## ADDENDUM 1 – JOB 38

TO: All prospective bidders on project SU-6-986(121)125, Job No. 38 scheduled for the November 17, 2017 bid opening.

### ADDENDUM 1 – JOB 38

TO: All prospective bidders and suppliers on **Project SU-6-986(121)125, Job No. 38**, in Grand Forks County, City of Grand Forks, scheduled for the November 17, 2017 bid opening.

Light Standard Detail

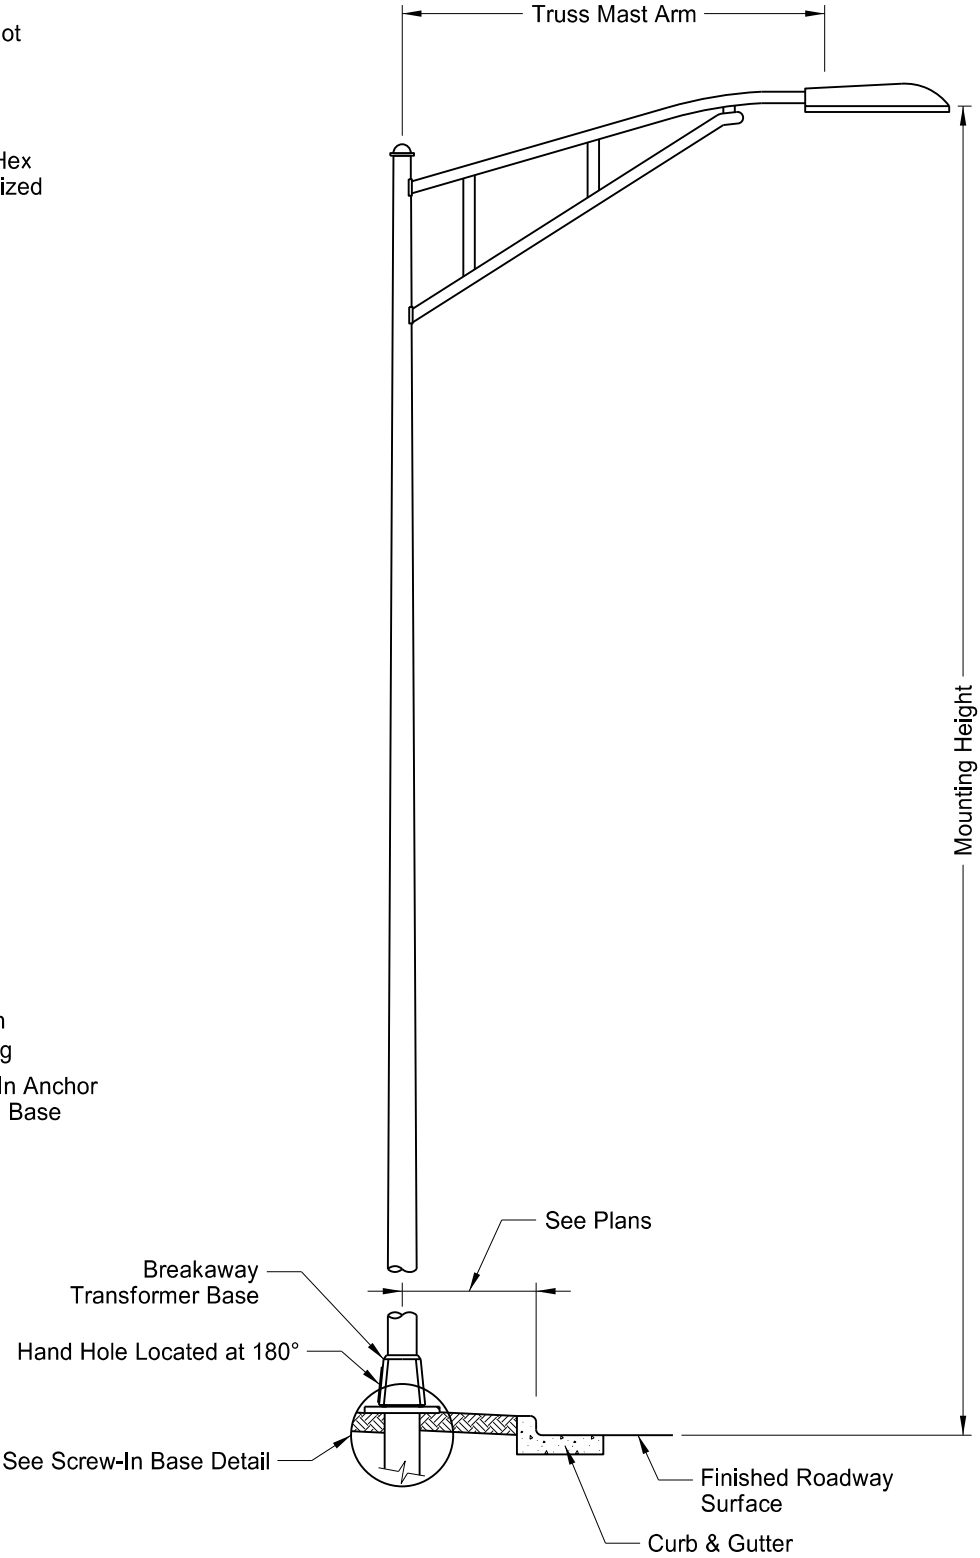
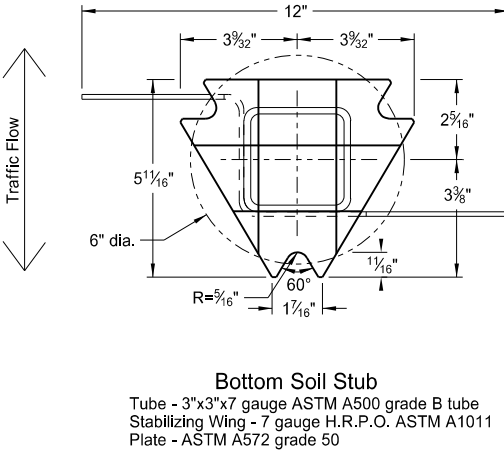
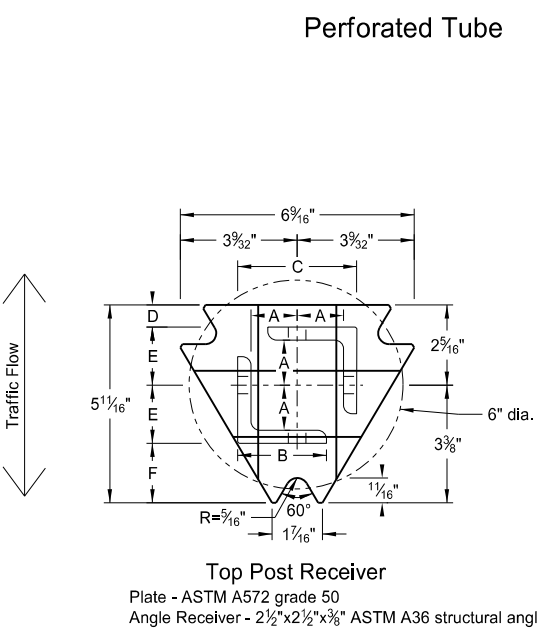
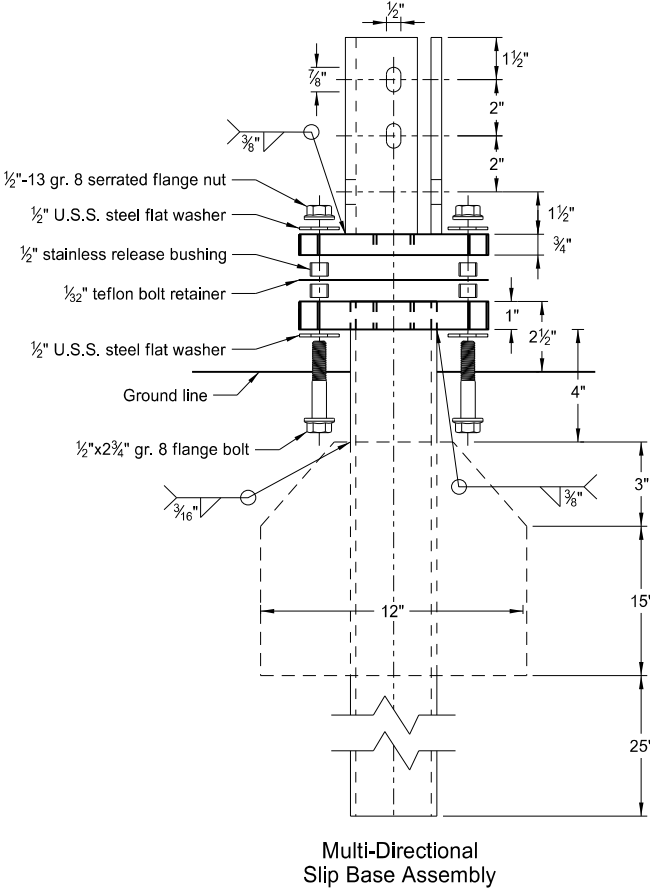
120	2	Item 762 0118 EPOXY PVMT MK CURB TOP & FACE added; Quantity shows 27 LF
140	7	Pay Item 770 0320 1.5IN DIAMETER RIGID CONDUIT; quantity increased from 492 LF to 529 LF.
140	15	The light standard detail was clarified to show that festoon outlets are not required; decorative brackets were also deleted from the light standard detail.
Standard Drawing	D-704-7	Updated to active voice
Standard Drawing	D-704-8	Updated to active voice
Standard Drawing	D-704-13	Updated to active voice
Standard Drawing	D-704-14	Updated to active voice
Standard Drawing	D-708-6	Updated to active voice
Standard Drawing	D-762-1	Updated to active voice
